**SERVICE BULLETIN**

**APPLICABILITY:** 2013MY Impreza 2.0L NA Models  
2013MY XV Crosstrek™

**NUMBER:** 11-127-13R

**SUBJECT:** ECM Reprogramming Availability for DTCs  
P0017 & P0019

## Intake Flow Chart

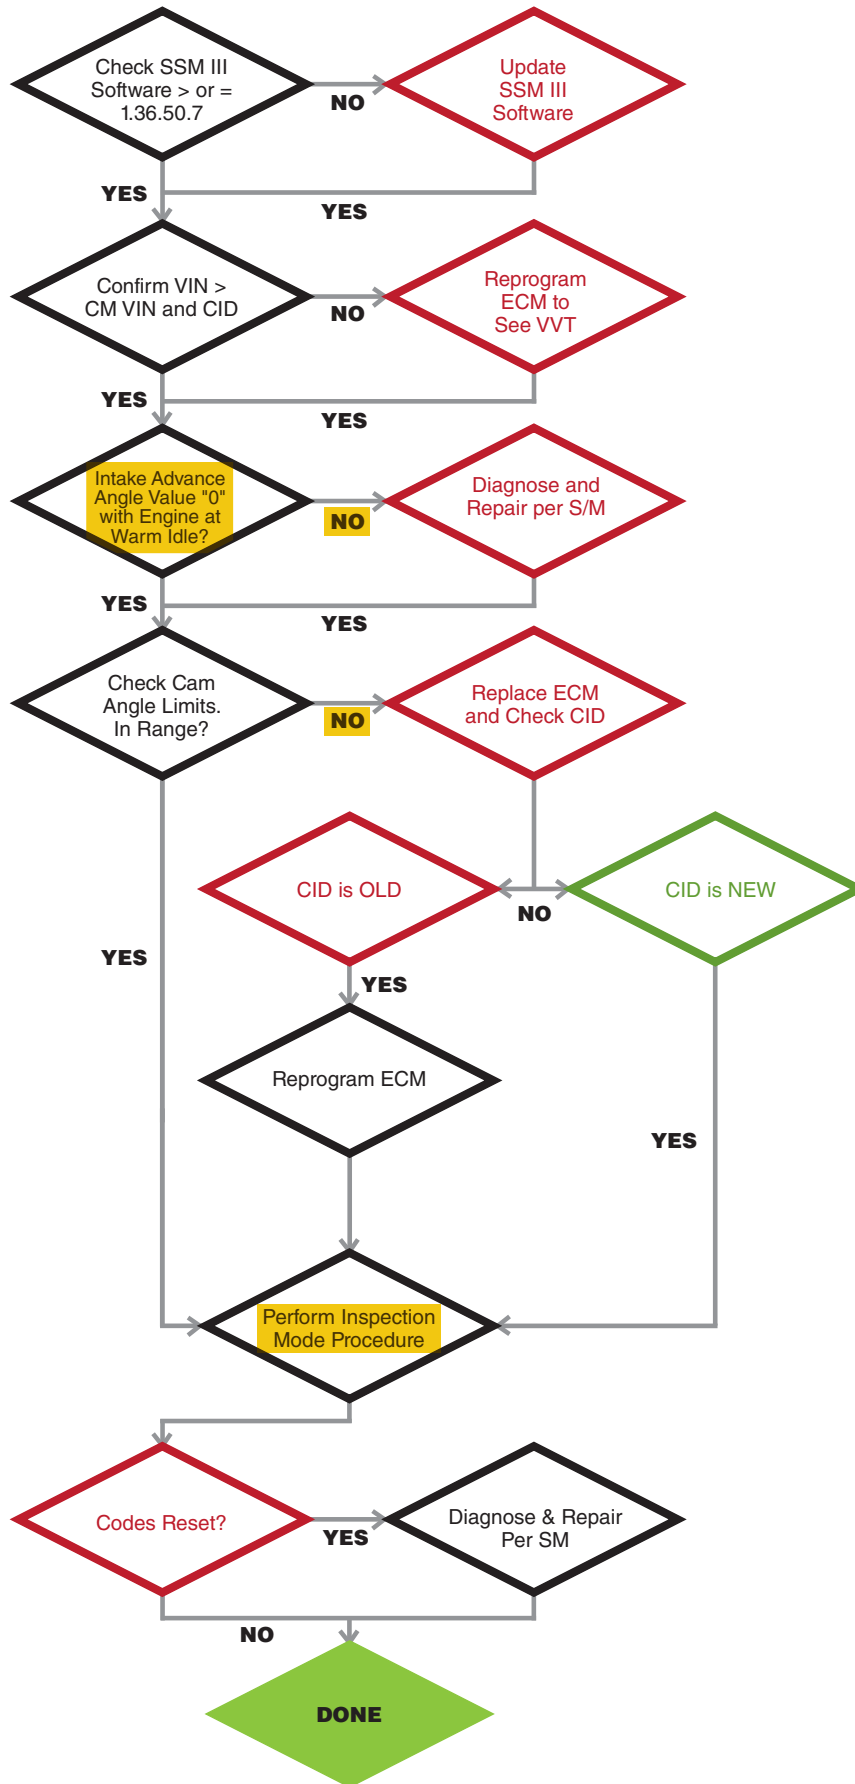
For the **INTAKE**, the chart above shows values within the Specified Limits (number crankshaft angle degrees) which are a **MINIMUM of 50** and a **MAXIMUM of 70**. Check the SSMIII data for VVT Advance Angle Amount as shown below.

With the engine at idle and at operating temperature, this value must be “0”. If confirmed to be “0”, proceed with the remaining steps on the INTAKE Flow Chart. If not “0”, diagnose and repair the VVT system per the Service Manual.

- If the ECM is determined to be OK, clear the memory and perform Inspection Mode to confirm no DTCs reset. If P0016, P0017, P0018 or P0019 reset, diagnose per the applicable Service Manual. If no DTCs reset, the vehicle is repaired.
- If the ECM needs to be replaced, install the latest part number available then verify the CID number is the latest available as shown on the chart below. If the new ECM installed is not the latest (NEW) part number, update it with the appropriate PAK file as listed below. Following reprogramming, confirm the CID then matches the NEW CID NUMBER as listed on the chart below.

## Exhaust Flow Chart

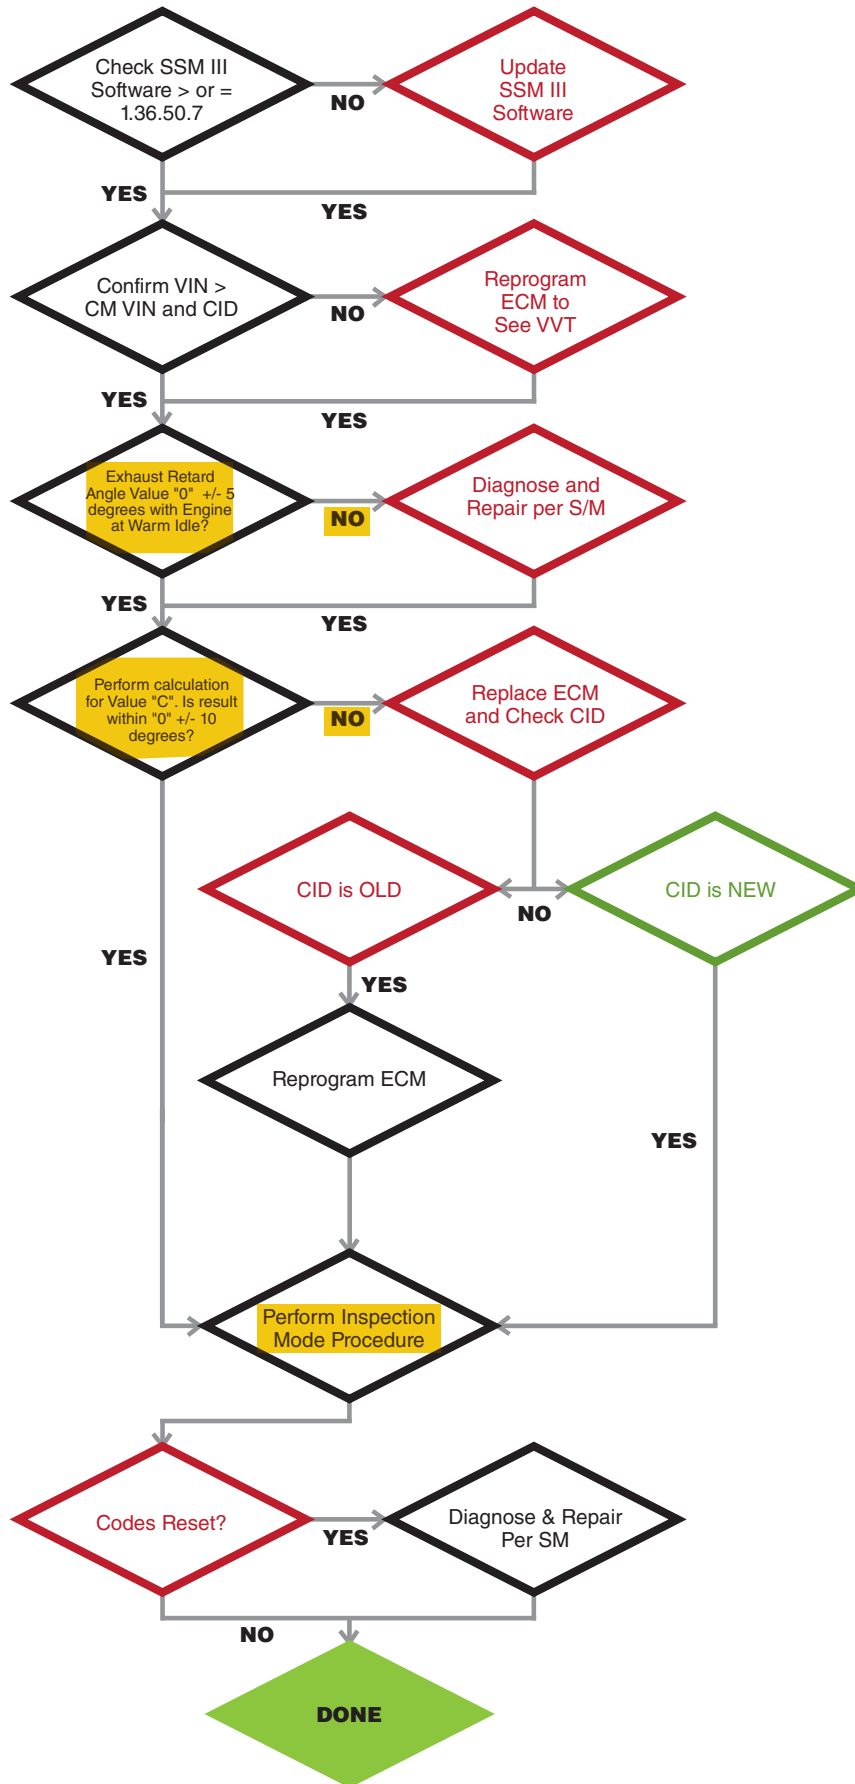
For the **EXHAUST**, the formula shown below must be used to determine if an ECM replacement is needed. Check the SSMIII data for Exhaust VVT Retard Angle as shown below. The specified range for this value is “0” +/- 10 degrees.

- **A=** Exhaust VVT Retard Angle Value, read with the engine at idle and at operating temperature (This value may be a positive or negative number.)
- **B=** VVT Exhaust Initial Position Learning Value
- **Formula: C = A + B - 90** (The 90 value in the formula represents the midpoint of the Specified Limit range.)

Does the value of C = “0” +/- 10 (degrees)?

1. **Yes-** Perform Inspection Mode and if no DTCs reset, the car is repaired.
2. **No-** Replace the ECM then follow the remaining steps on the Flow Chart.
